PROPOSED NEW HARBOUR AT WYNYARD :

REPORT BY C. NAPIER BELL, M. INST. C.E.

REPORT ON PROPOSED NEW HARBOUR AT WYNYARD.

April, 1890.

Wynyard New Harbour.—Design for extended Breakwater.

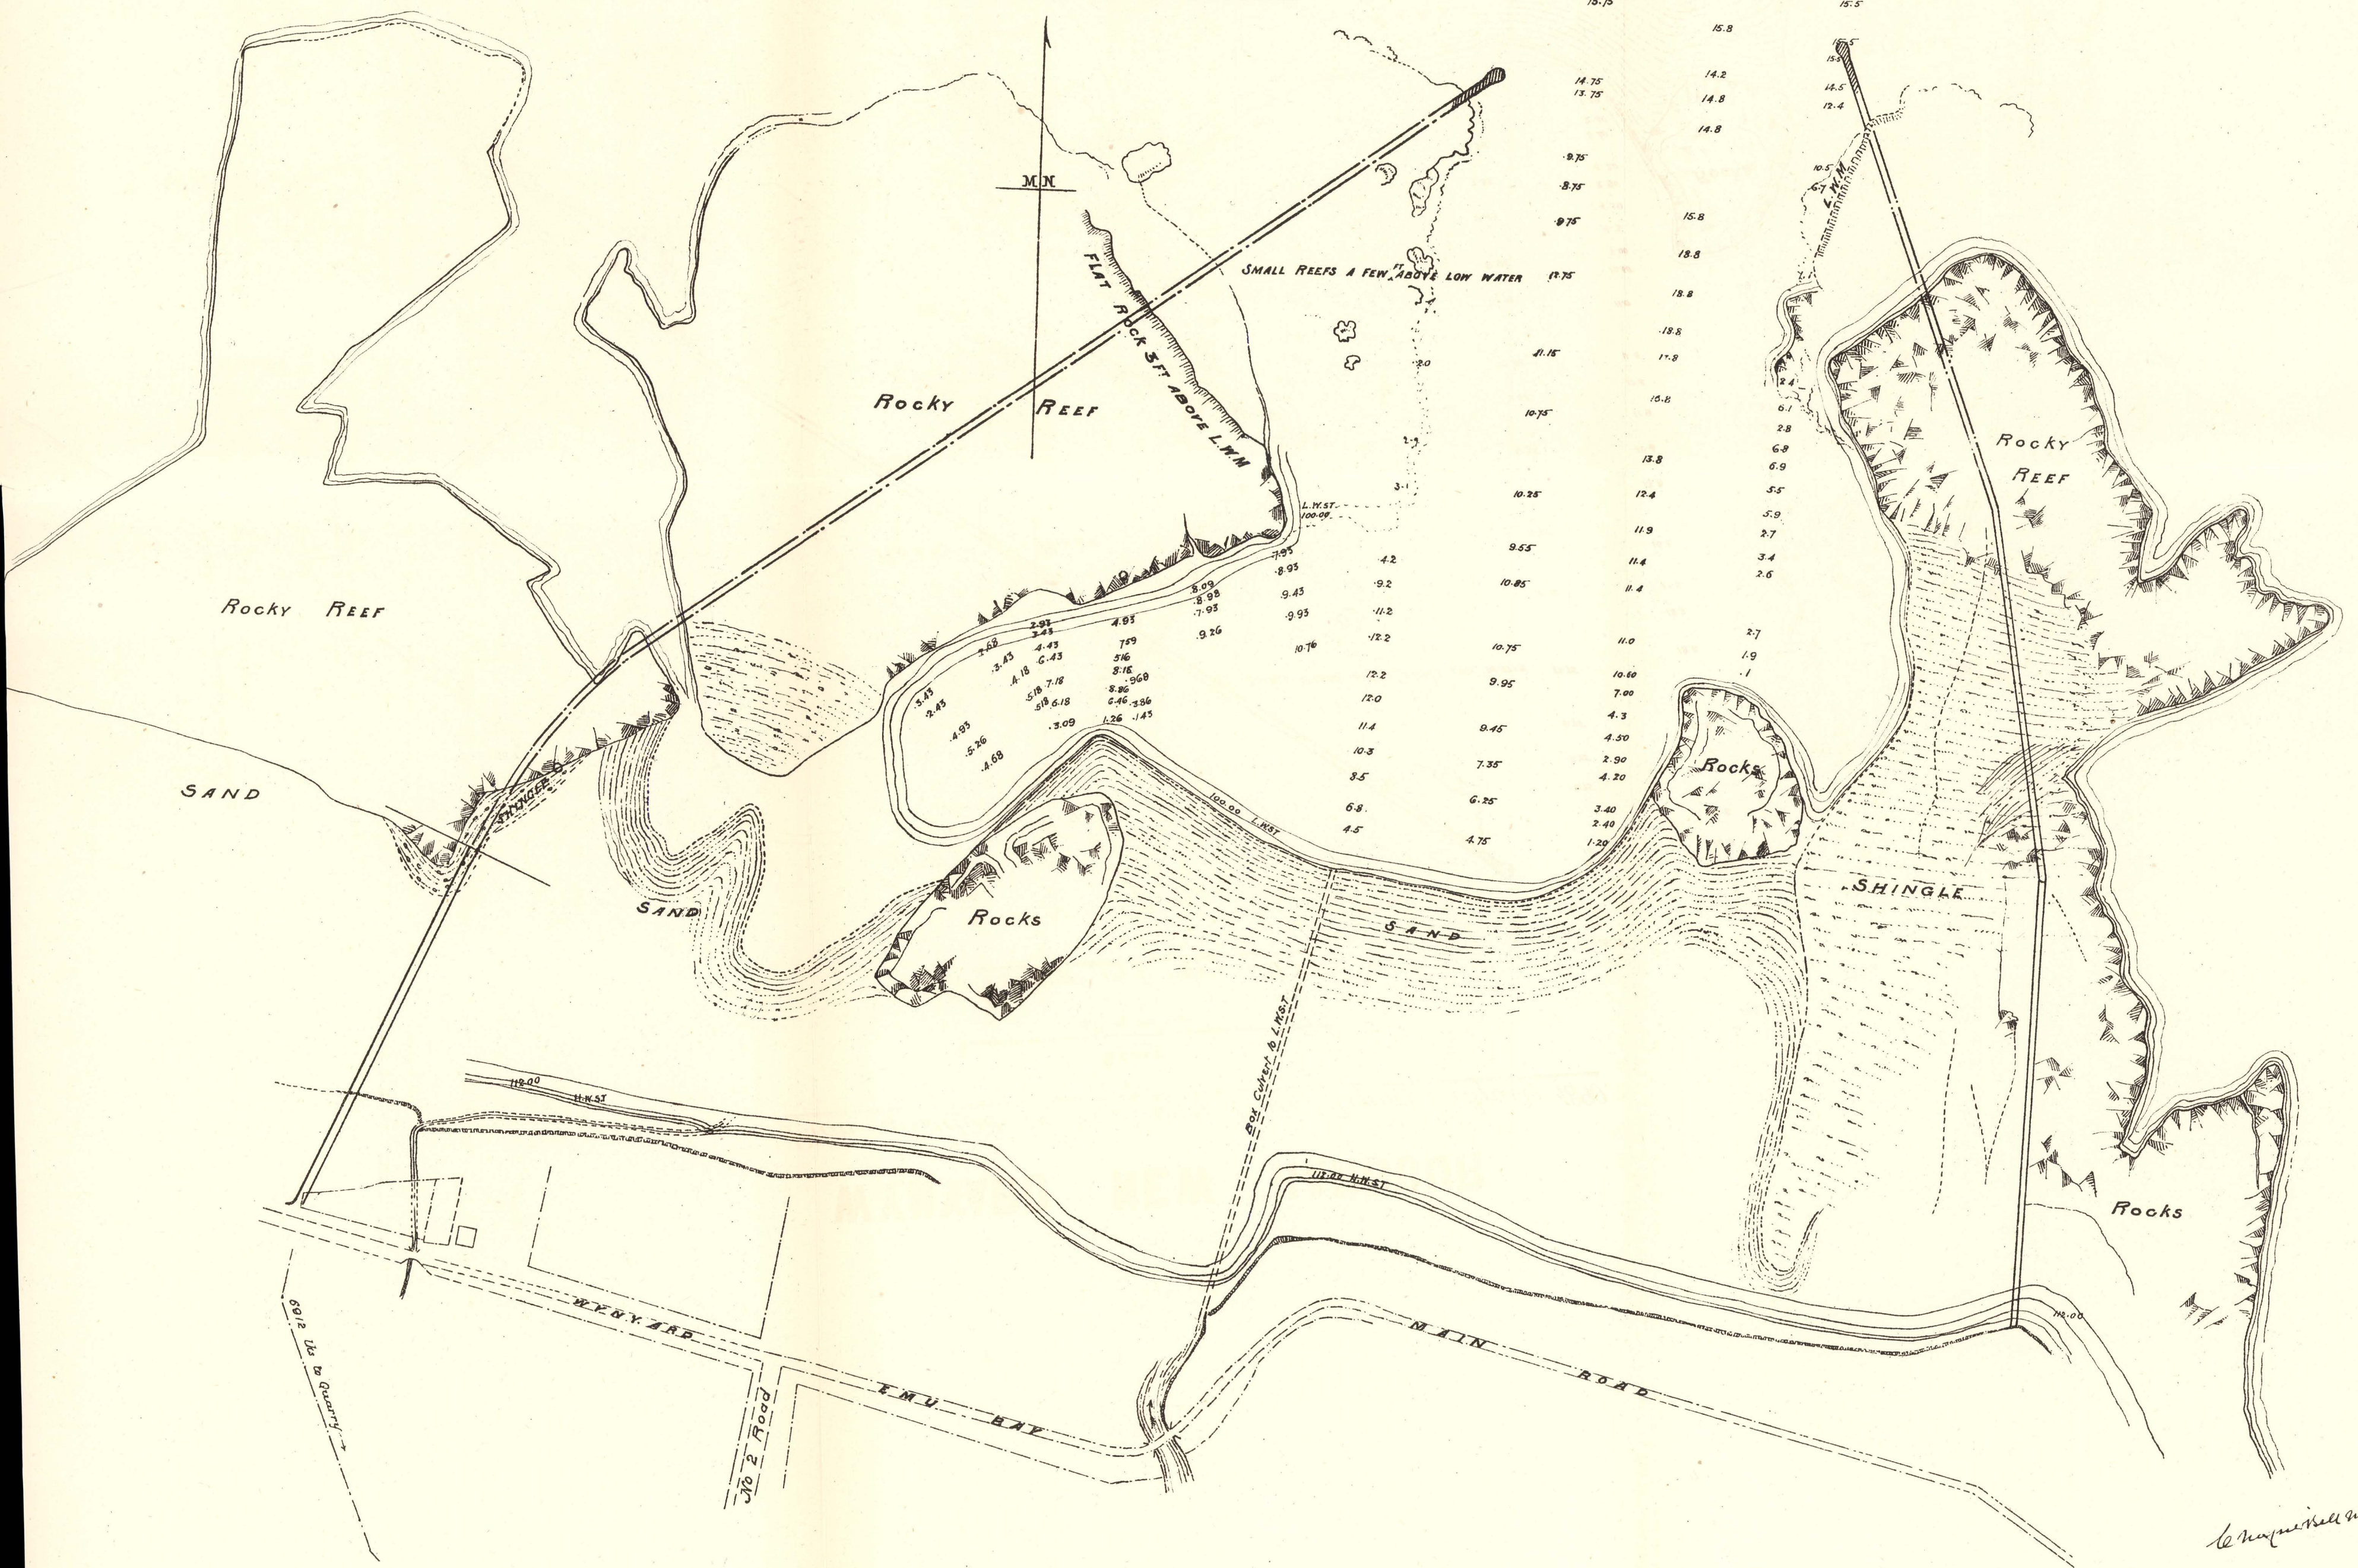
The objections on account of the smallness of the harbour, and of the risks attending the entrance in rough weather, would to some extent be obviated if the narrow entrance and crooked turns were brought under shelter, which would be done if the breakwaters were extended further seaward; there would then be more room to bring up and turn or stop in sheltered water. I have shown on the plans the position of such extended breakwaters, but I have not sufficient information at hand to enable me to give any precise estimate of the cost.

The original plans show the ends of the breakwater to be of concrete blocks, built upright. In this position this is necessary, because the entrance is so narrow that the slopes of a rubble mound would encroach upon the necessary width. In the position I have shown, with the breakwaters extended further seaward, the width is ample, and the breakwaters can be made of rock in the form of an embankment, the slopes protected with heavy rock of from 1 to 10 tons weight, and this form of construction is much more economical.

By extending the breakwater as shown this harbour would be a fairly good one, but for large steamers it would always be inconvenient from its cramped position at the wharves, and the care required to navigate it. The sunken rock at the entrance is a danger which requires attention and careful handling of a ship. For small vessels this would make a good and useful harbour. Large steamers, however, might object to call at a port which requires extra care in navigating, for small
